UNITED STATES PATENT AND TRADEMARK OFFICE

| APPLICATION NO. | FILING DATE | FIRST NAMED INVENTOR | ATTORNEY DOCKET NO. | CONFIRMATION NO. |
|-----------------|-------------|----------------------|---------------------|------------------|
| 09/964,127 | 09/26/2001 | Fariborz Assaderaghi | AUS9-1999-0711-US2 | 2012 |

Office Action Summary

DETAILED ACTION

Fig. 8

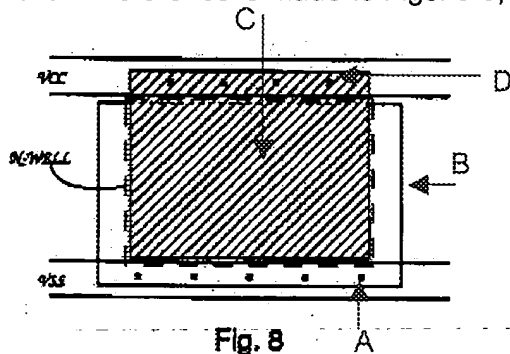
1. Figs. 8-9 describe depletion mode transistors (col. 3, ll. 44-46) (*Figs. 8-9 above have been modified by adding labels to clarify discussion of the figures*).
2. Fig. 8 is a plan view, while Fig. 9 is a cross-sectional view at a location between the VCC and VSS lines. The examiner has added labels to help explain the understanding of the reference.

A: points to the solid squares at the lower portion of the device body, which the examiner understands to be contact vias extending between the Vss wire and the N+ region in the substrate.

B: points to the solid-rectangular line that overlaps the Vss line and surrounds the solid square contact vias that are labeled A.

C: points to the polysilicon upper capacitor electrode.

D: points to the solid squares at the upper portion of the device body, which the examiner understands to be contact vias extending between the Vcc wire and the polysilicon upper capacitor electrode (labeled C).

3. The N-well is labeled inconsistently between Fig. 8 and Fig. 9. The line connecting the "N-WELL" label of Fig. 8 to a dash region that is nearly co-extensive with the polysilicon gate is clearly a drafting error since the Vss region would contact neither the N-well nor the N+ regions and would not be in contact with the lower capacitor electrode. It appears that this line was simply added in error because the location of the N-well label (without line) in Fig. 8 is consistent with the location of the N-well in Fig. 9. That is, the N-well is outside of the N+ region and surrounds the N+ region. The boundary between the p- region and the n-well region is outside of the region depicted by Fig. 8 or is simply not shown. With this understanding, the dashed line connected to the n-well label likely corresponds to the capacitor dielectric which is co-extensive with the upper capacitor electrode in both Figs. 8-9.

not state what region (B) is. Region (B) in Fig. 8 corresponds to the N+ region in Fig. 9 since (1) both are connected to the ground terminal (Vss), (2) both appear to be aligned to the polysilicon layer in a manner that is commonly known for doping source/drain regions in the MOSFET context, and (3) the labeling of the N-well in Fig. 8 is clearly a drawing error and is properly given little weight in understanding Figs. 8 and 9. The capacitor plate (herein labeled C) is tied ("tied . . . directly to Vcc power bus") to the power bus by way of contacts (herein labeled D) of Fig. 8.

electrically connecting the first and second lateral regions (N+ regions) to a first supply voltage potential (Vss) at a first longitudinal end of the device body (solid square N+ contacts at the lower side of the device body in Fig. 8); and electrically connecting the electrode layer (polysilicon electrode) to a second supply voltage potential (Vcc) at a second longitudinal end of the device body opposite to the first longitudinal end of the device body (solid square contacts at the upper side of the device body, Fig. 8).

Applicant states: "Figure 8 of the 821 patent appears to show Vss connections at outside the N-well of the device structure." If it is true that Vss connections are outside of the N-well structure, then the lower capacitor electrode (diffused regions) would not be connected to Vss

(ground terminal). However, it is abundantly clear from Chern '821 that the lower capacitor electrode must be connected to Vss (ground terminal) to result in an operative depletion mode capacitor. (see claims 1 and 3 of Chern '821, Vcc (power bus), Vss (ground potential)). Accordingly, this ambiguity in the drawings does not render the above findings incorrect.

Applicant states: "The Examiner also suggested that Figure 8 of the 821 patent is mislabeled and that the N-well in the structure in fact comprises the solid rectangle rather than the dashed rectangle shown in the drawing." This is incorrect since the solid rectangle in Fig. 8 corresponds to the N+ regions in Fig. 9. The border between the N-well and the p-substrate is not shown in Fig. 8 or it is outside of the area depicted in the figure.

Fig. 9

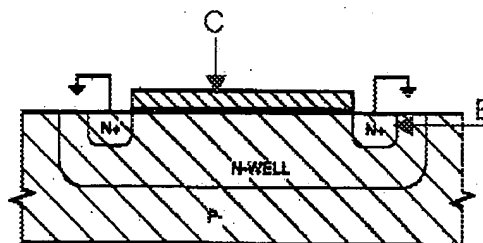
4. Fig. 9 shows the lower capacitor plate (N-well and N+ region) connected to the ground ("one node is tied directly to the substrate"; claim 1, clause (d)). Vss denotes a ground terminal. Fig. 9 shows contacts (herein labeled A) that extend between Vss and a region of the substrate (herein labeled B). Fig. 9 shows diagrammatically that the N+ regions are connected to the ground terminal. Fig. 8 shows that Vss (ground terminal) is connected to region (B), but does
